1 **Draft Interim Review of PRM-50-93/95 Issues Related to**
2 **Loss-of-Coolant Accident Simulations in the National Research Universal (NRU)**
3 **Reactor**
4
5

16
17 **1.0 Issues Raised in the Petitions and Associated Comments**
18

7
 8
 9 **Figure 1.** Temperature at start of reflood –vs- temperature rise for all NRU TH-1 tests

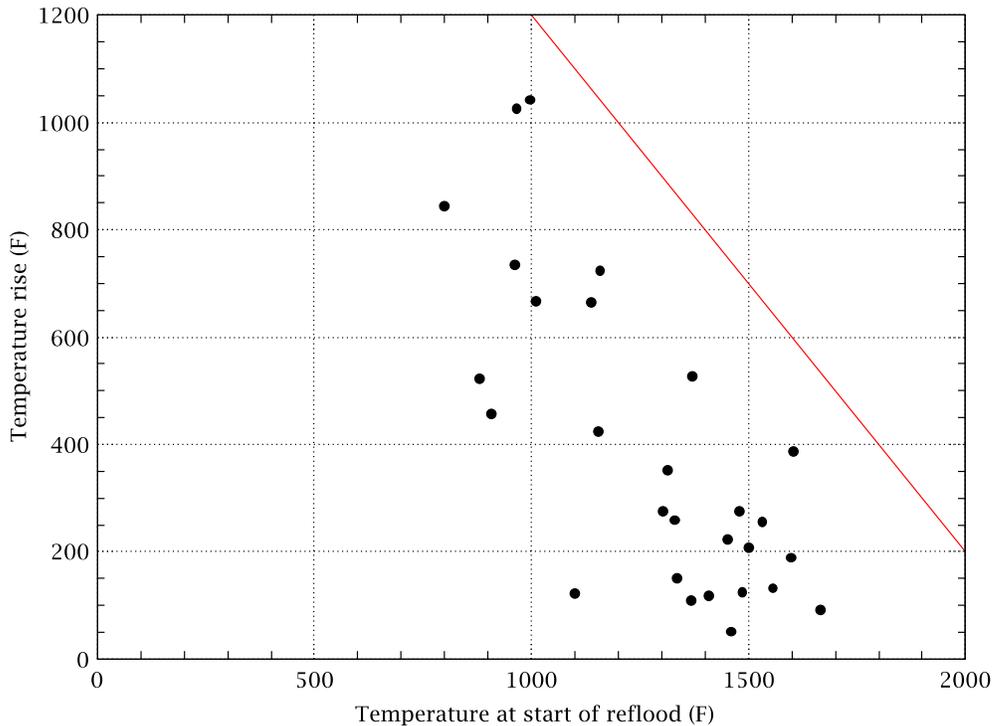
38
39 The petitioner states that the TH-1 tests illustrate that low reflood rates do not prevent Zircaloy
40 cladding temperatures from having substantial increases. There are numerous parameters that
41 are known to have an important effect on reflood hydraulics in a light water reactor. No single
42 parameter completely controls the peak cladding temperature for a particular transient. Basing
43 a conclusion on any single parameter can be misleading. Part of the basis for the petitioners
44 request for a limit on reflood rate, is the significant temperature increases observed in the NRU
45 reflood tests. Starting from initial cladding temperatures less than 1,000°F, several NRU tests
46 produced temperature increases of over 1,000°F. The petition cites several NRU tests as
47 examples (tests no. 127 and 130). The petition implies that similar, or larger, temperature
48 increases would occur if the initial cladding temperatures had been 1,200°F or more. This is not

49 correct, however. Thermal radiation becomes more important in transferring heat away from hot
50 spots, and as rod temperatures increase the temperature difference between the cladding and
51 the coolant increases. Figure 1 below shows the temperature at the start of reflood –vs– the

1 temperature rise for all the NRU TH-1 tests. These include various reflood rates and delay
 2 times. As seen in the figure, as the cladding temperature at the start of reflood increases, the
 3 overall temperature rise decreases. The red line on the figure shows the margin to a PCT of
 4 2,200°F. Thus, contrary to the claim made in the petition, “extrapolation” of data does not show
 5 “with high probability” that peak cladding temperatures will exceed 2,200°F.
 6

1
2 **Figure 2.** Temperatures for NRU TH-1 Test 130 from NUREG/CR-1882
3
4

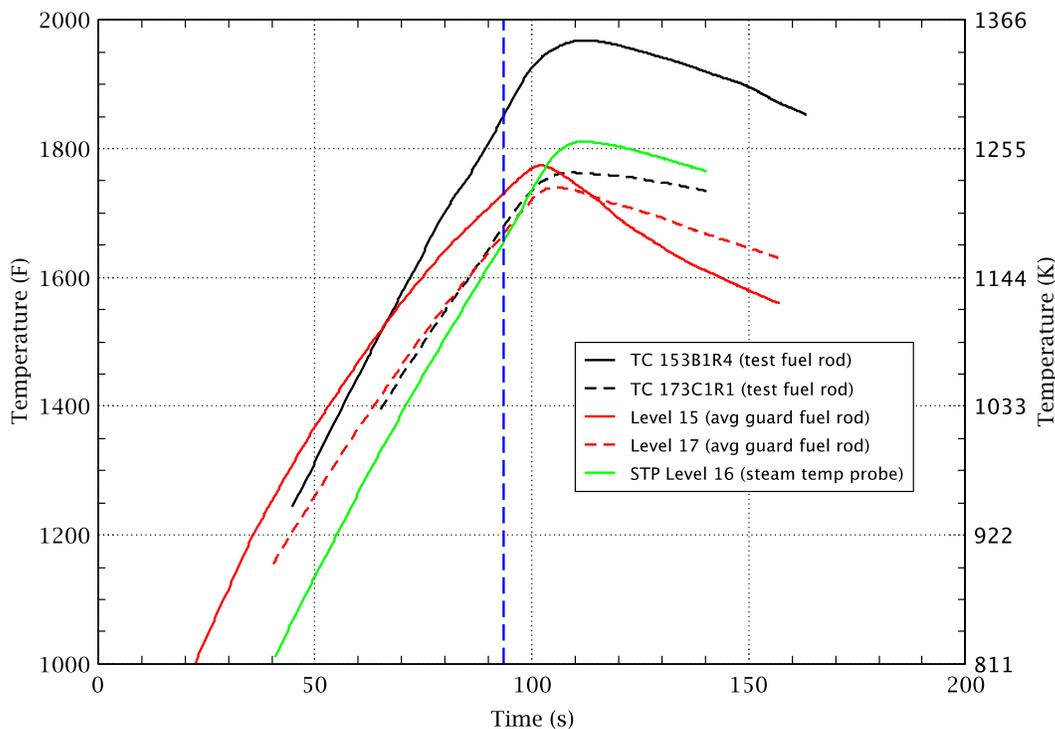
9
10 To investigate this further, applicable portions of several temperature plots for TH-1 test no. 130
11 (shown in Figures 1.2.3.30, 1.2.4.30 and 3.2.2.30 of the Appendix to NUREG/CR-1882) were
12 digitized and recreated and shown in Figure 2 below. The highest temperature shown in the
13 plots for test no. 130 is 1,968°F, which is lower than the 2,040°F given in Table 1 of
14 NUREG/CR-1882, so the peak cladding temperature location is not shown in the plots and it
15 cannot be determined exactly how much the peak cladding temperature increased after reactor
16 power was stopped. While it is not known at exactly what time the reactor was tripped, it would
17 be expected that there would be some change in the rate of temperature increase when the
18 reactor trips and power begins to decline. Looking at the slope of the temperature curves
19 (dT/dt) shows no noticeable change in any dT/dt prior to 100 s. While the temperature may

20 continue to increase at some locations (due to the metal-water reaction), it is extremely unlikely
21 that it would continue to increase at the same rate at all locations shown in the temperature
22 plots, particularly those below 1,800°F. Assuming the reactor was tripped and power began
23 decreasing at 102 s (the first observed change in dT/dt), then thermocouple TC153B1R4 would
24 be at 1,940°F and reach a maximum of 1,968°F, a difference of 28°F. While this is not the
25 location of the peak cladding temperature, this is the thermocouple with the highest temperature
26 plotted in NUREG/CR-1882 and is representative of the thermal transient. This is a significantly
27 smaller temperature increase than the 190°F quoted by the petitioner. Given that the reactor
28 did not trip at a PCT of 1,850°F, there is no basis for the petitioners' claim that a temperature
29 increase of 190°F was due to the metal-water reaction after the reactor shutdown.

38
39 While the peak cladding temperature would have gone higher than 2,040°F if the reactor was
40 not tripped, there is no justification or evidence provided by the petitioner to substantiate the
41 claim that autocatalytic oxidation would have occurred.
